PL2023-188

OLDHAM VILLAGE PHASE 1 PRELIMINARY DEVELOPMENT PLAN

Modification

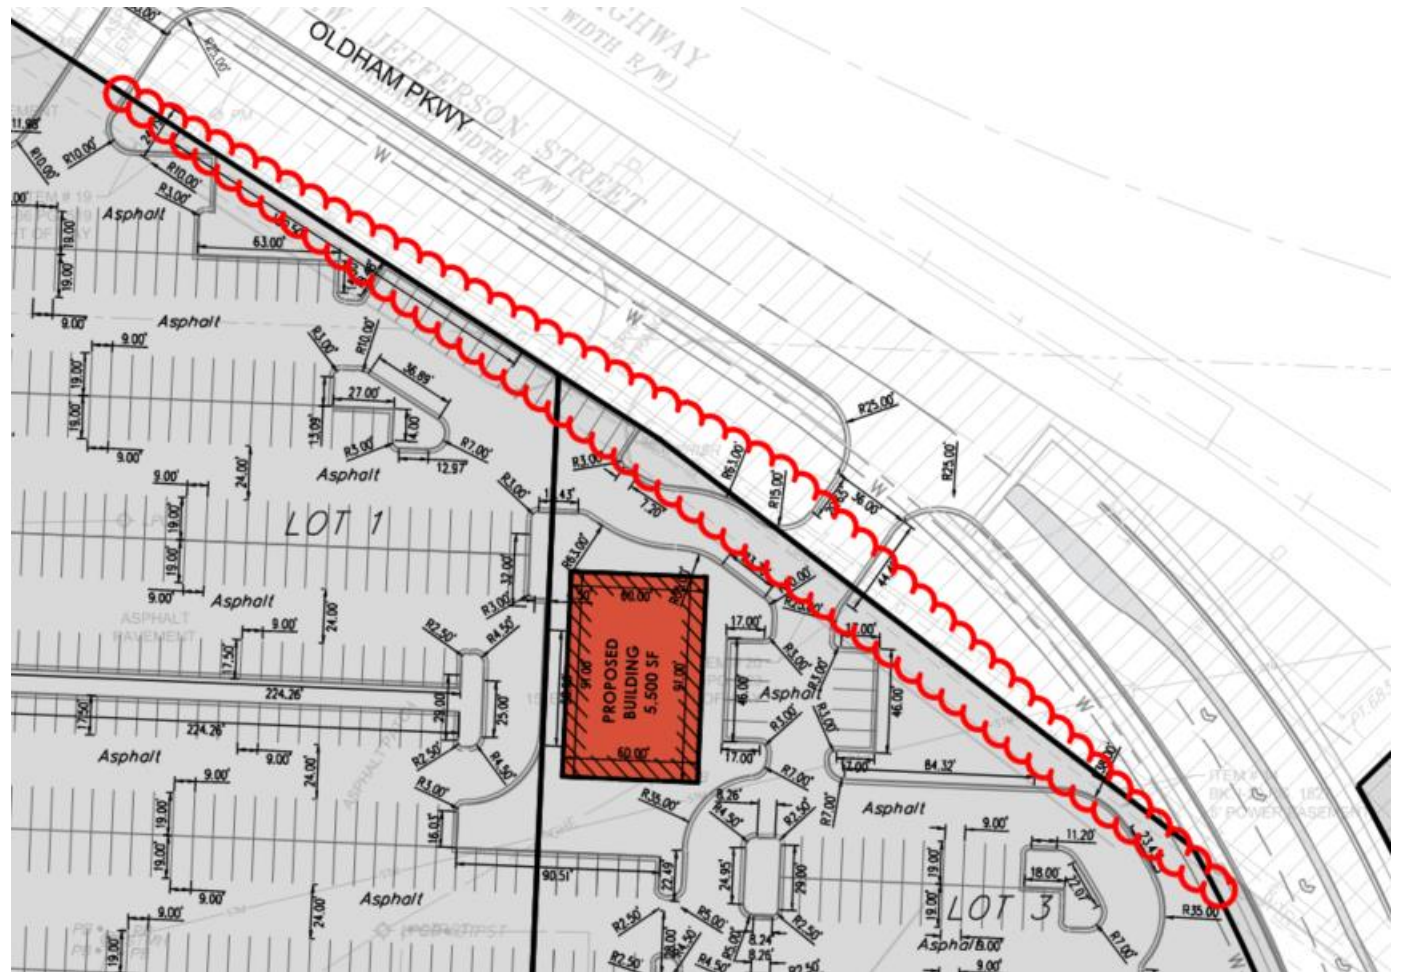
- Required – Min. 20' parking lot setback from ROW
- Proposed – Min. 0' parking lot setback from SW Oldham Pkwy/US 50 Hwy ROW

1. A modification shall be granted to the minimum 20' parking lot setback from the right-of-way, to allow parking lot setbacks ranging from 0' to 18' along SW Oldham Pkwy, US 50 Hwy and South M-291 Hwy rights-of-way as depicted on the preliminary development plan.

Road Improvements – Phase 1

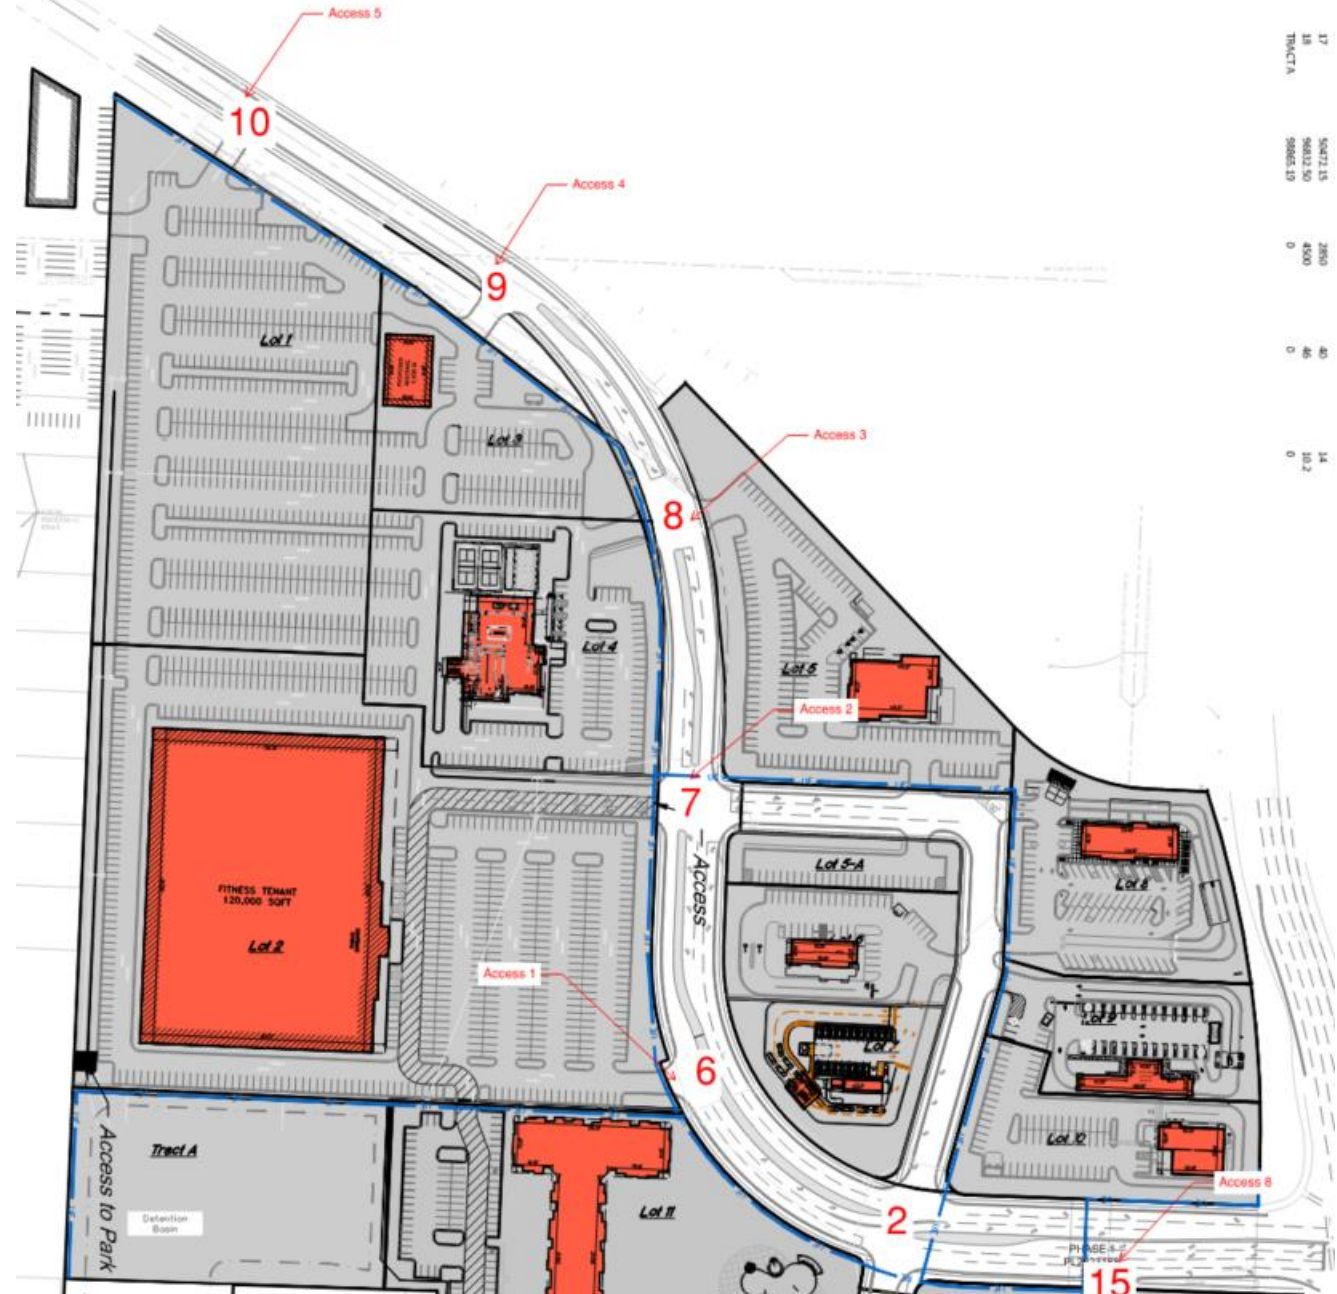
- Install signal
- NB left-turn lane
- SB left-turn lane
- 3-lane EB and WB approaches

5. Road improvements for Phase 1 shall be constructed as recommended in the Transportation Impact Analysis conducted by staff dated August 26, 2024.
6. Approval shall be granted for two (2) primary identification monument signs with an overall height of 30', 224 sq. ft. sign face area and 312 sq. ft. overall sign structure area.

Recommendation

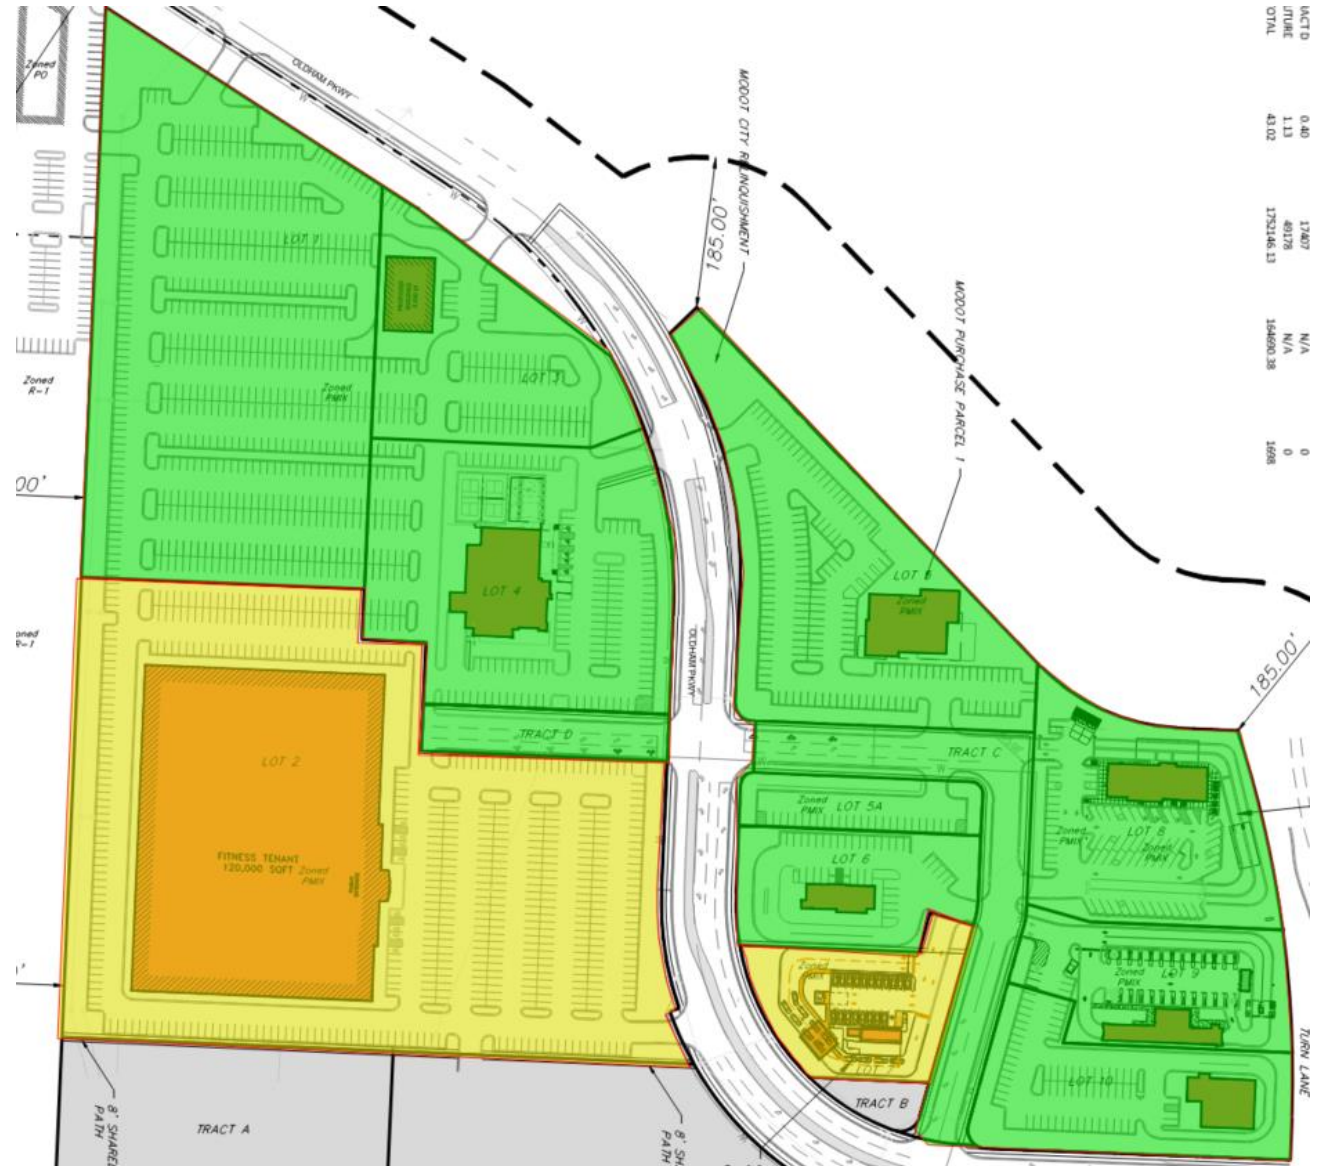
- Lots 1, 3-6 and 8-10 (in green)

- Lots 2 and 7 (in yellow)

4. Development shall be in accordance with the preliminary development plan dated August 13, 2024, and building elevations uploaded August 2, 2024. However, Lots 2 (fitness facility) and 7 (Smalls Sliders) are approved with conceptual approval only and a preliminary development plan shall be required for said lots prior to final development plan approval.
